# Port of Anchorage - North Expansion Projects

# **Summary of Findings**

### **Suitability Summary Report**

**US Army Corps  
of Engineers**  
Alaska District

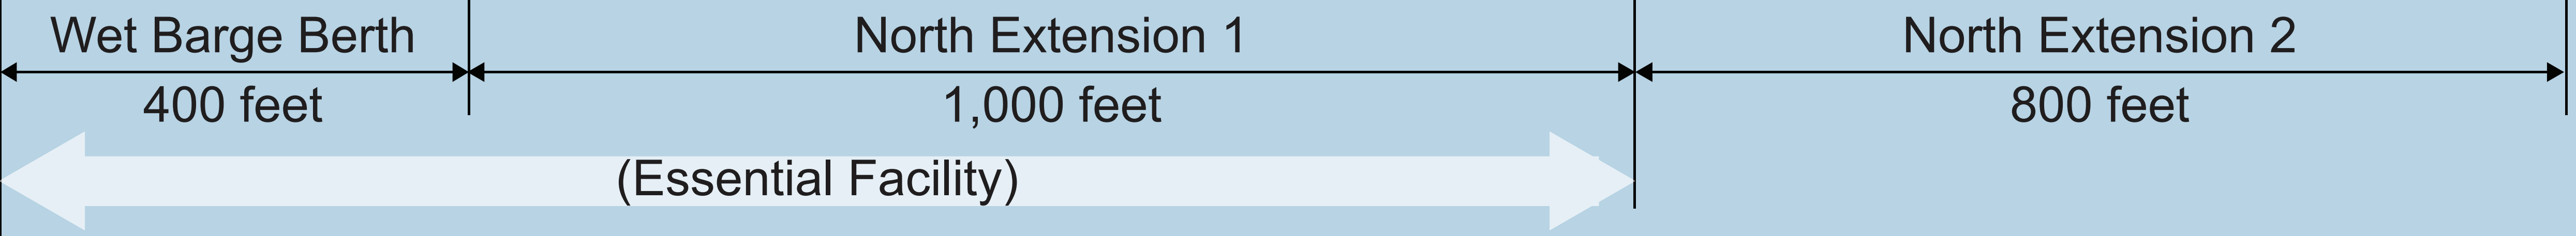
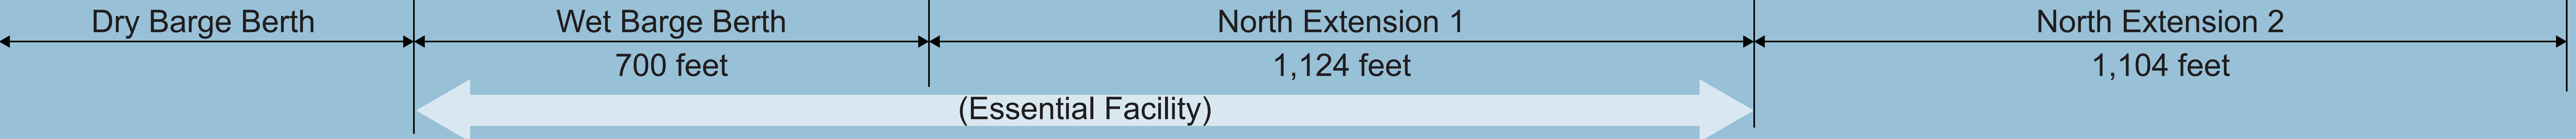
The WBB was not successfully constructed, as major defects in the installed sheet piling have been documented. Additionally, the factors of safety for global stability are not adequate for the WBB. The 63-foot wall height in the WBB is more than twice the 26-foot height of the DBB, and this contributes directly to the lower factors of safety.

- WBB During Operation (Static) – Standard = 1.5, Analysis result = 1.22
- Conclusion: Deficient

The NE1 had many damaged sheet piles and defects that have been repaired according to the original designer. However, this section of the OCSP® is about three times as high as the DBB and has even lower factors of safety than the WBB.

- NE1 During Operation (Static) – Standard = 1.5, Analysis result = 1.1
- Conclusion: Deficient

The NE2 was not successfully constructed, as major defects in the installed sheet piling have been documented. The factors of safety for this area are the lowest of the four sections due its 89-foot wall height, which is over three times the height of the DBB.

- NE2 During Operation (Static) - Standard = 1.5, Analysis result = 1.13
- Conclusion: Deficient

The existing condition of the North End structure as designed and constructed is deficient in critical aspects and must be replaced and/or repaired to achieve a 50 year functional life.
